RAILWAYS AND PUBLIC WORKS:

REPORT OF THE ROYAL COMMISSION.

ROYAL COMMISSION
ON
RAILWAYS AND PUBLIC WORKS.

REPORT
OF
THE COMMISSIONERS,

DERWENT VALLEY RAILWAY
RETAINING WALL AT BACK RIVER
Scale 3/16" to one foot.

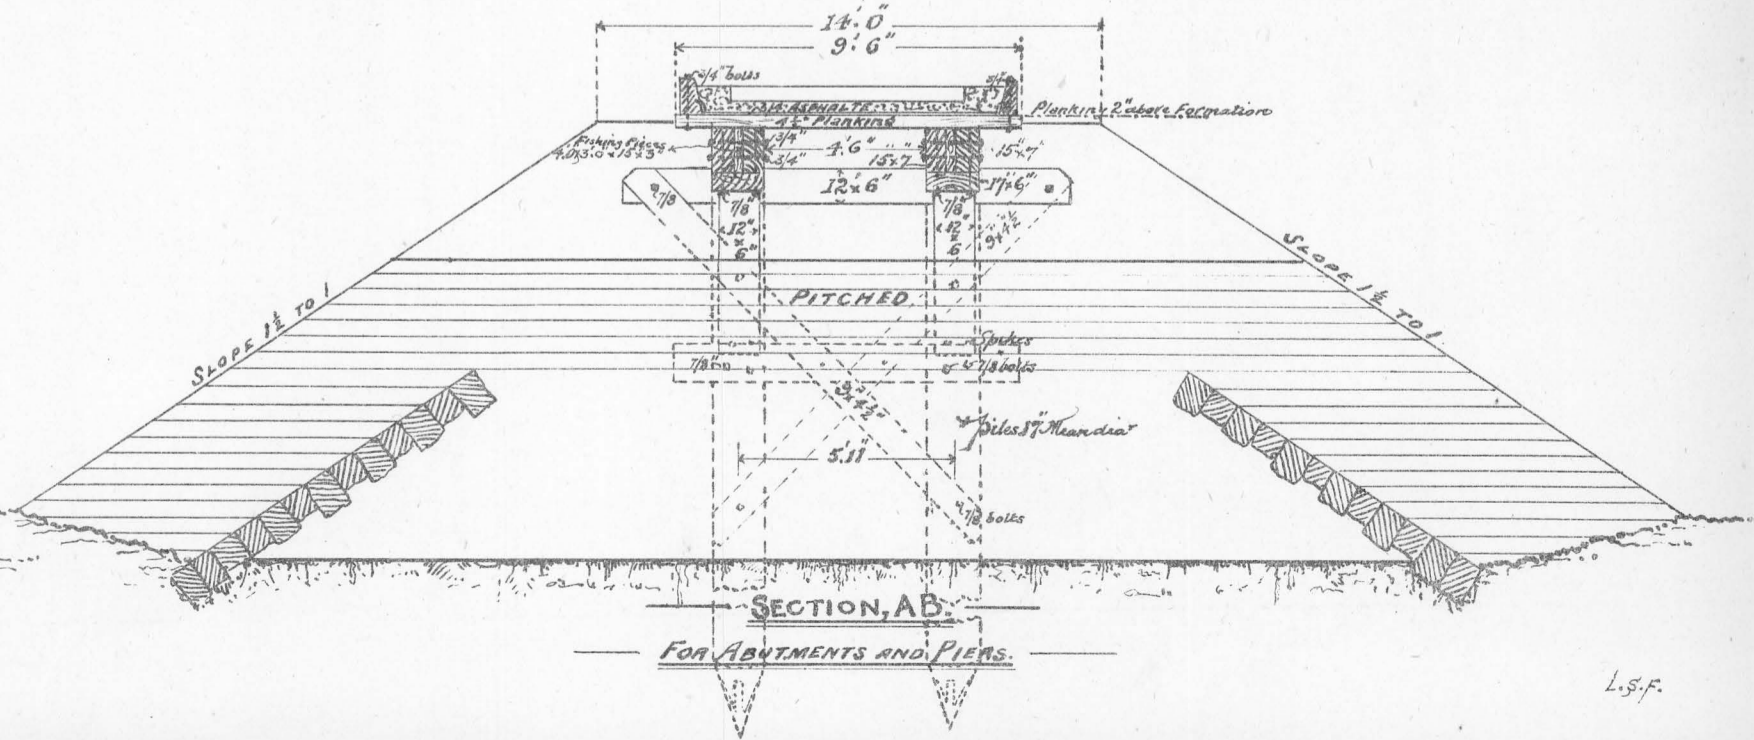
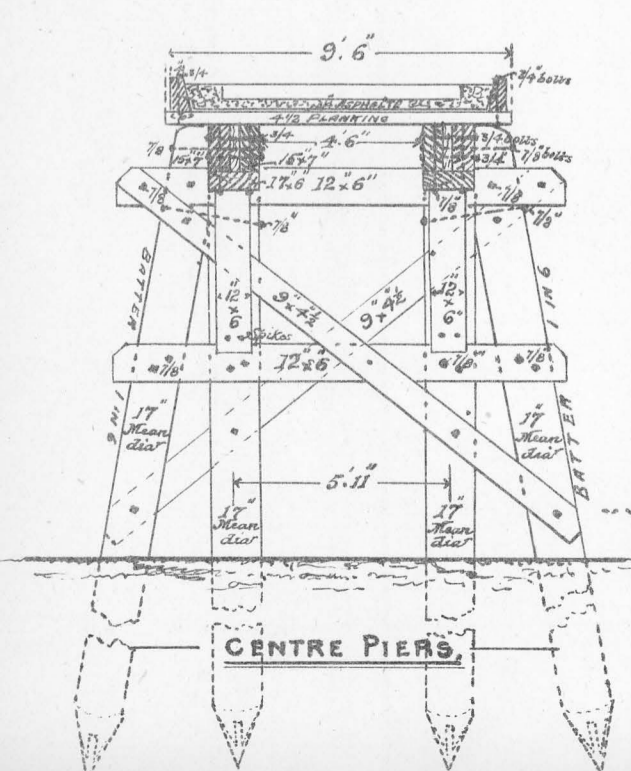
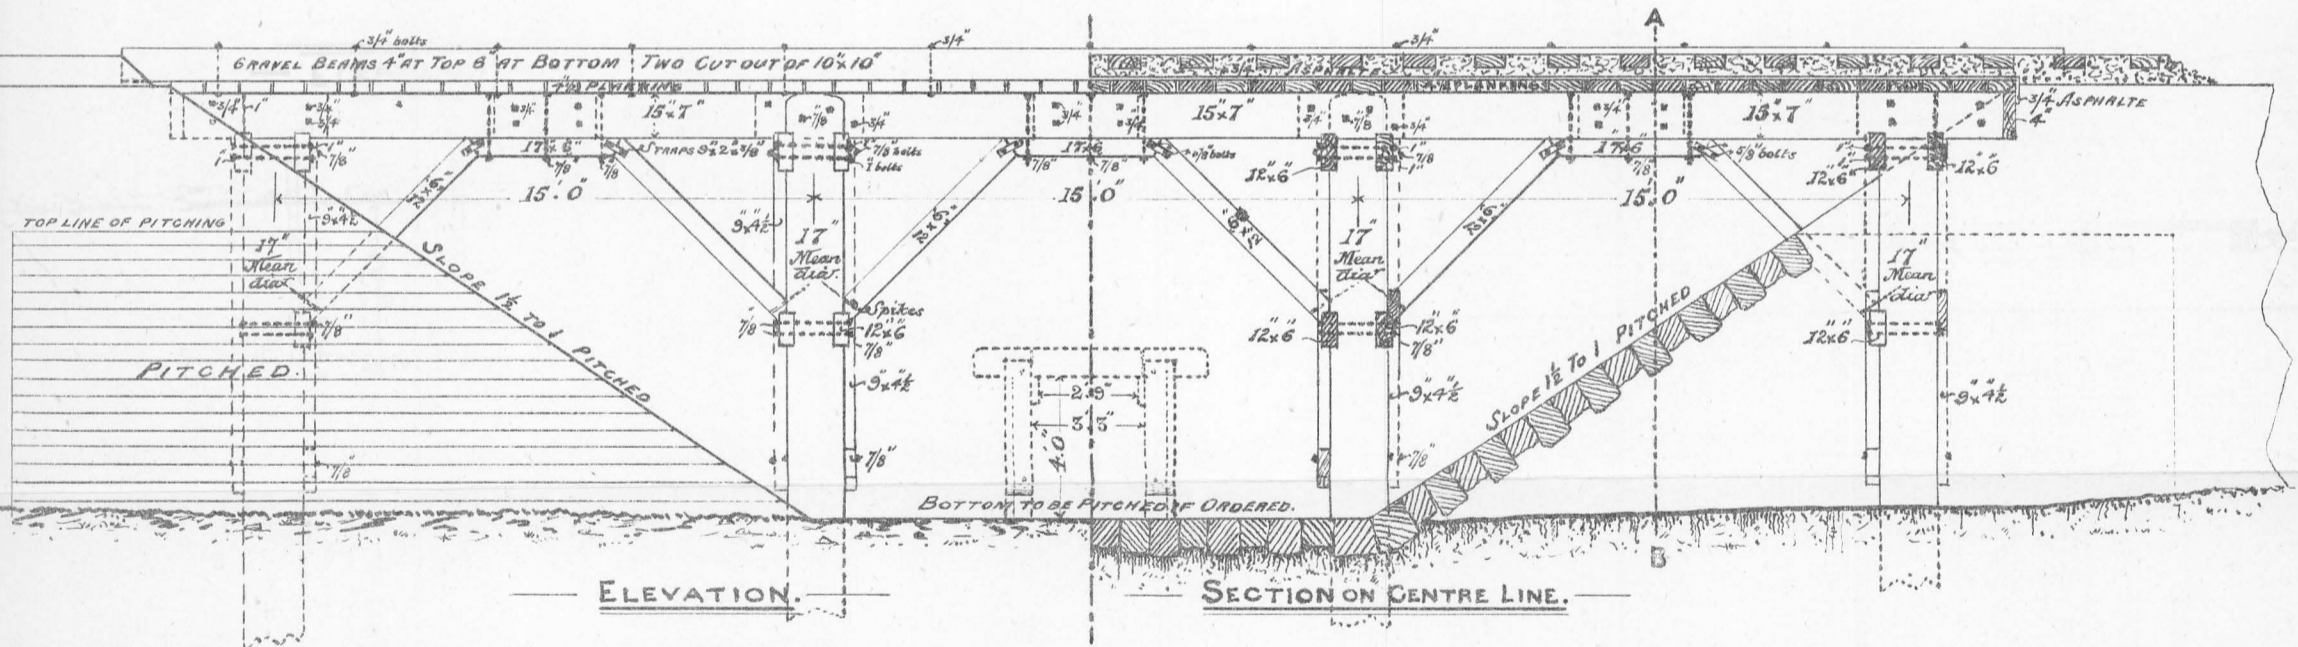
The culvert and retaining wall at Back River as originally built failed from a disregard (questions 144, 833, and 1222) of those precautions usually observed when building on doubtful foundations, and a departure from the ordinary principles of construction, whilst the form and quality of the material was

determined chiefly on questions of cost (page 61, par. 9). In the design of the present wall a want of constructive skill is apparent, an unnecessary mass of material (page 74, par. 10) being used in what can only be regarded as a rough and unscientific design.
